INITIAL RESPONSE
TO
THE OFFICE OF SURFACE MINING'S
APPARENT COMPLETENESS REVIEW

- SKYLINE MINES PROJECT -

MARCH 27, 1980

OFFICE OF SURFACE MINING - APPARENT COMPLETENESS REVIEW LETTER

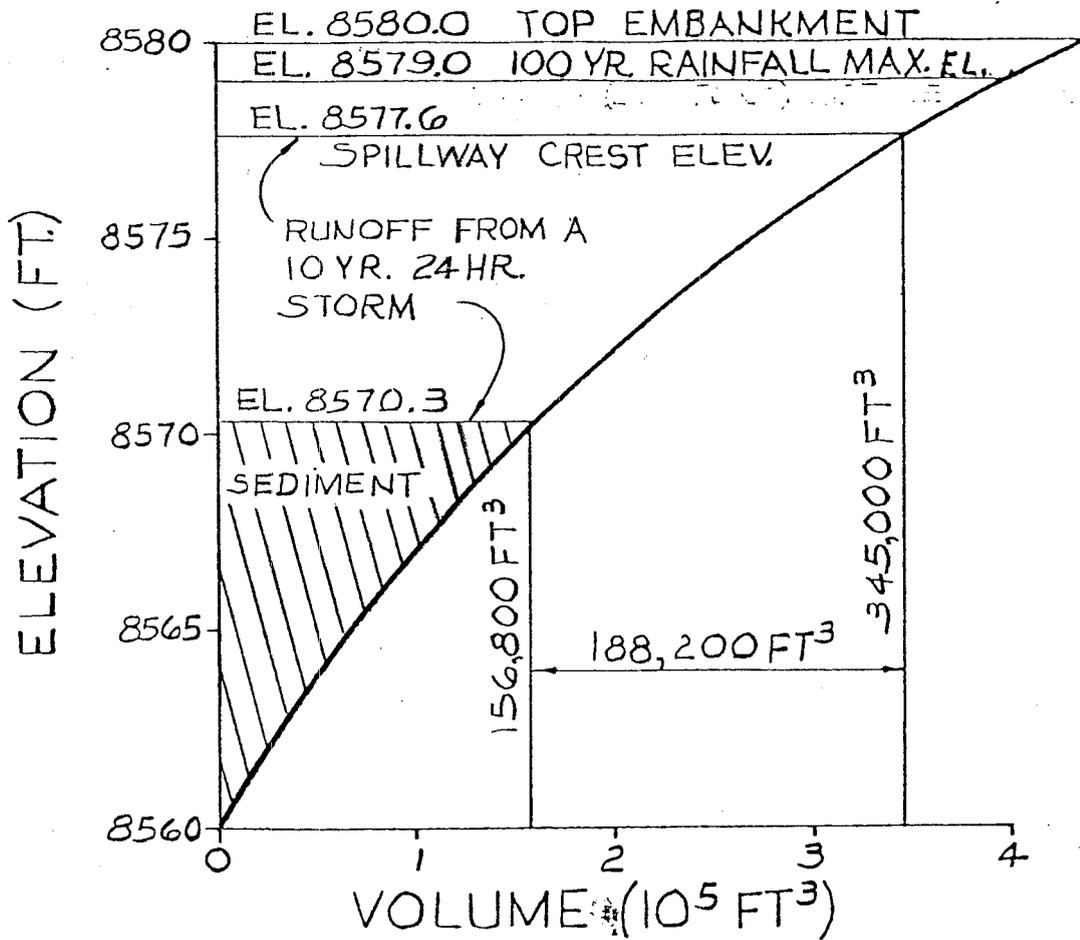
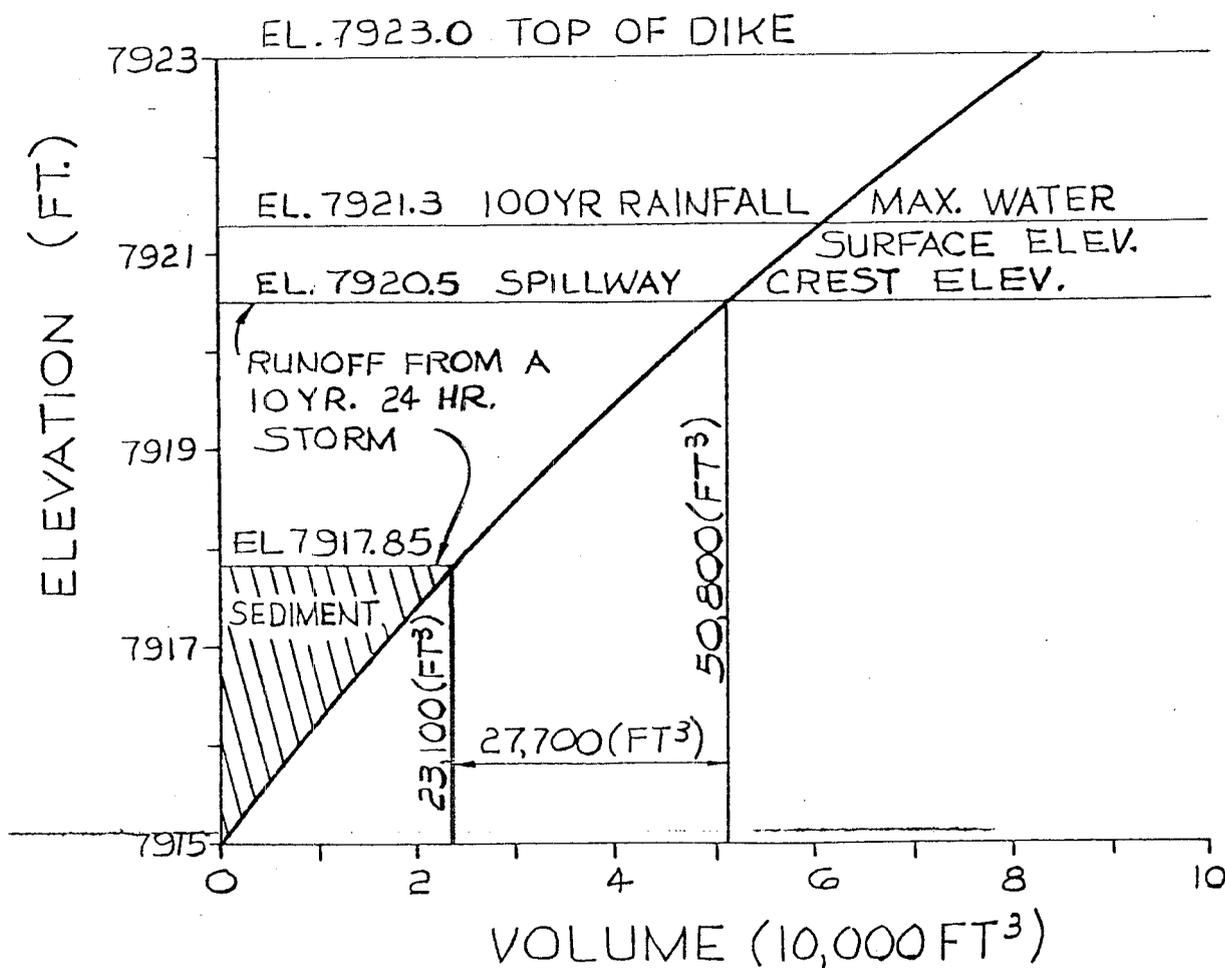
*7. The applicant must submit detailed plans for the design of sediment ponds prior to the consideration of the mine plan. If such plans are not submitted, a schedule for their submission must be supplied with the realization that no approval of this mining and reclamation plan will occur until such plans are submitted and evaluated.

The spillway riser at both ponds is set at an elevation such that the entire volume of runoff from the design storm event would be contained within the pond with no discharge if the water surface levels prior to the storm were at the sediment storage level or lower. This will allow retention of runoff water for essentially any period of time necessary to provide sediment removal. Each pond is provided with a dewatering valve located just above the sediment storage level to provide for discharge of the storm water when clarified. The sedimentation pond depth/capacity curves are shown on the attached figures 1 and 2.

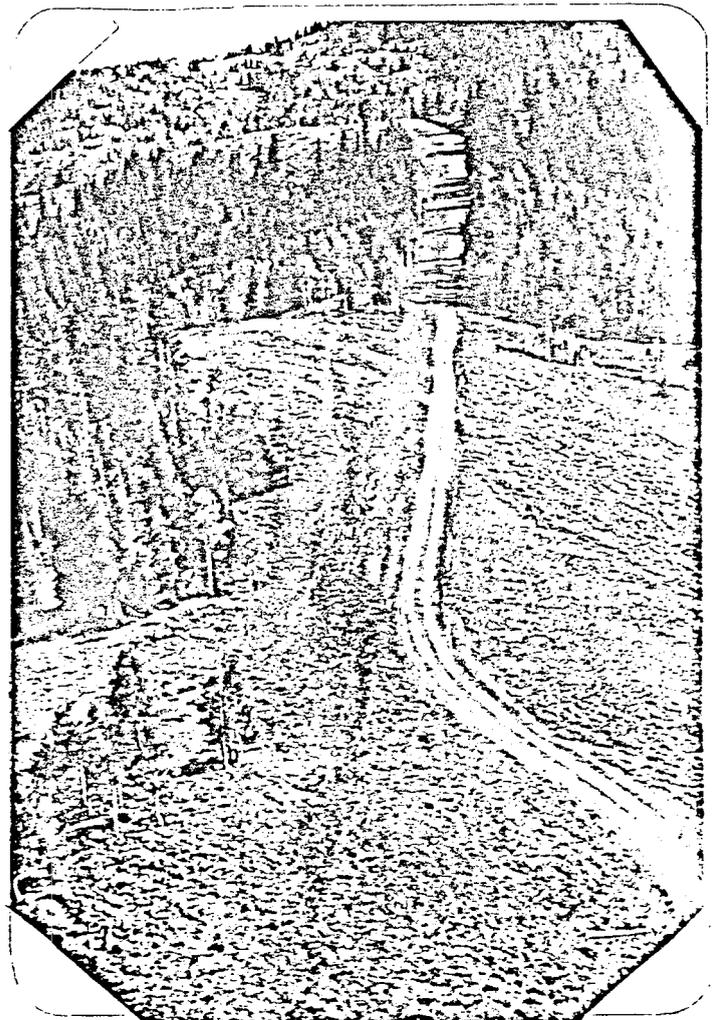
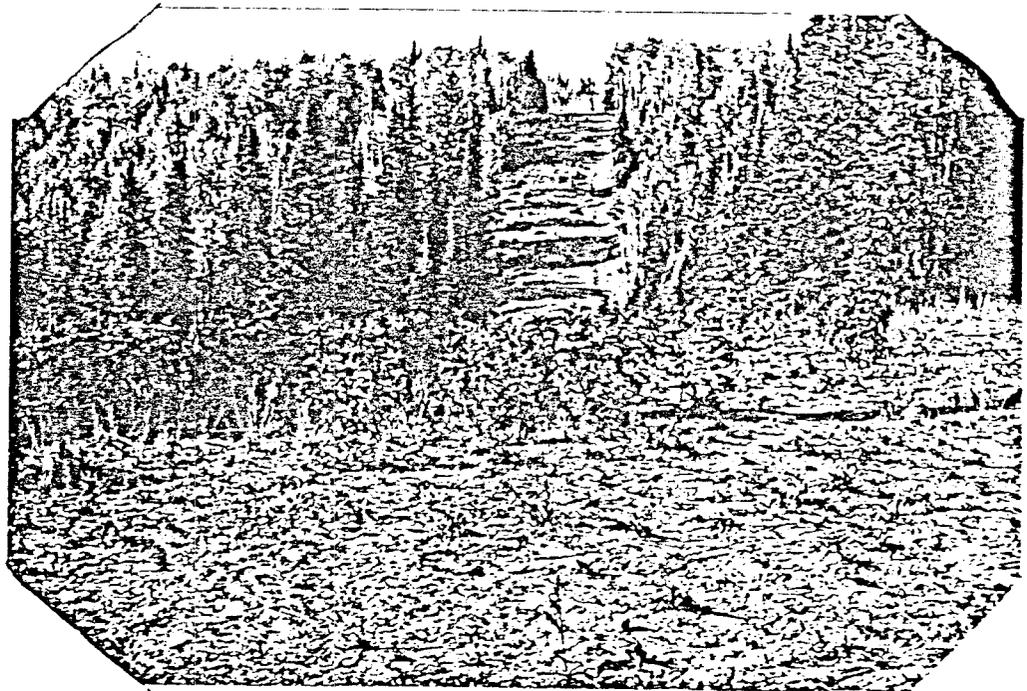
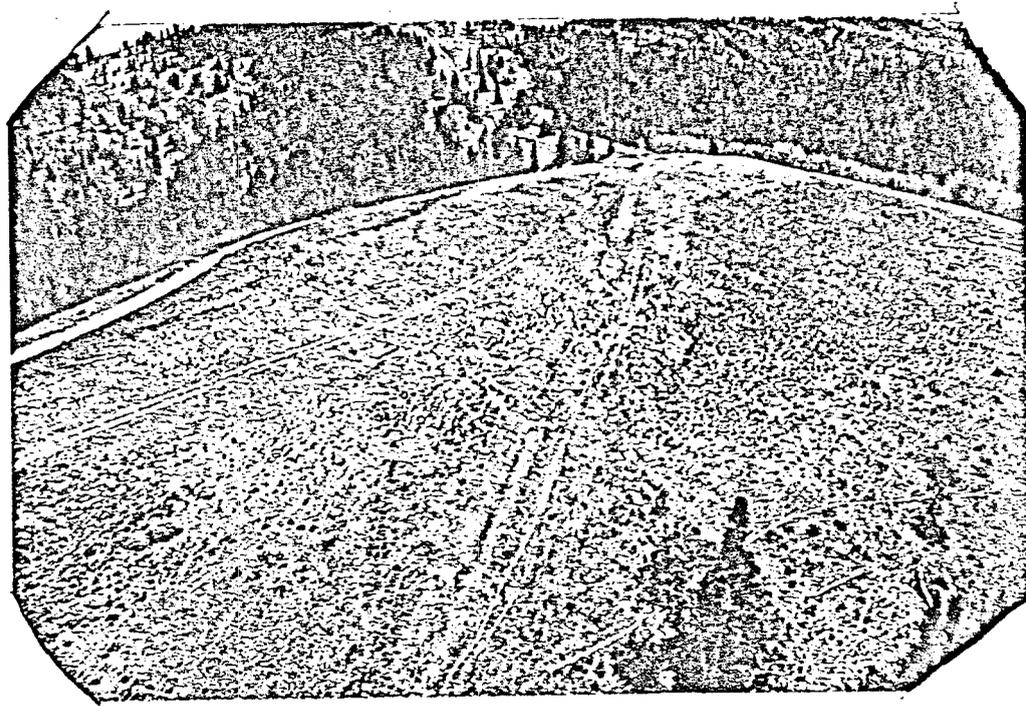
*2. The applicant must supply data showing detail on the potential for competitive replacement of native species by introduced species from the proposed seed mixture.

Deficiency 2.— The applicant must supply data showing detail on the potential for competitive replacement of native species by introduced species from the proposed seed mixture.

Photographs on pages 44 and 45 of the amended report show that reseeded grasses achieved almost 100% coverage, and with native forbs grasses and sedges encroaching on the pipeline area. It is also evident that the native sedges achieved as great a coverage as was present in adjacent undisturbed areas. Evidence of successful replacement on soils previously occupied by forest types is found in Photograph No. 1 of this reply. Seedlings of spruce are noted along the burn margin in rocky soil. Photographs 2 and 3 show successful establishment of elderberry and sagebrush across the pipeline corridor. Recolonization of the pipeline is evident in Photographs 4 and 5, especially by elderberry. In Photograph No. 6, low rabbitbrush is reestablished on shallow soils of an exposed ridge.
